Irvington Town Homes Testimony

LU 25-007018 HRM

Irvington Community Association
Land Use Committee

May 19, 2025

LUC Response to Proposal:

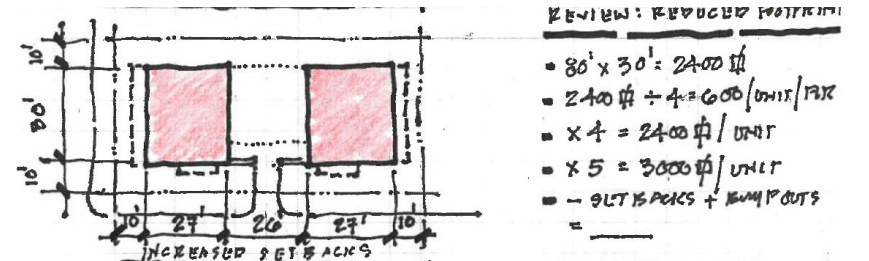
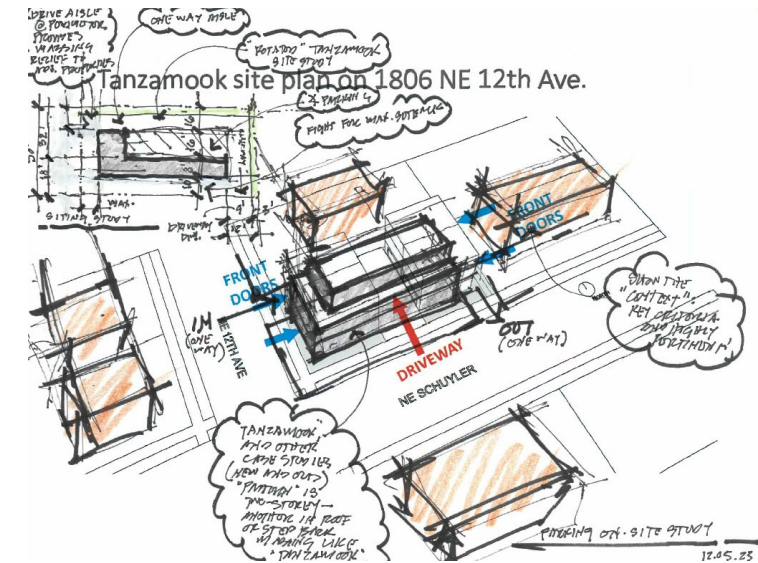
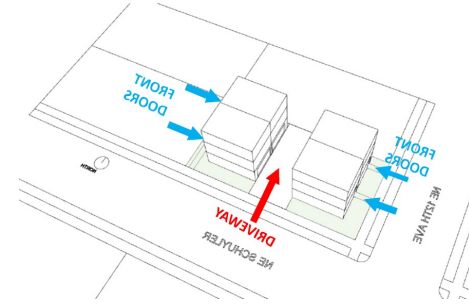
Overall, the LUC believes this proposal neither consistent with nor supportive of the historic district character directly (within 200') or the historic district character as a whole

- The proposed development siting and massing is simply too large for this specific site
- The proposed development makes no siting, massing or architectural design effort to related to the adjacent contributing resources
- The size, scale and massing of the proposed development is too large for this specific 5000sf site, seemingly resulting in the need to seek relief through setback modifications
- The proposed development, both in siting and massing, does not well address, negotiate or support the PP&D stated goal of “transitioning” from the zoned density to the south to that to the north.
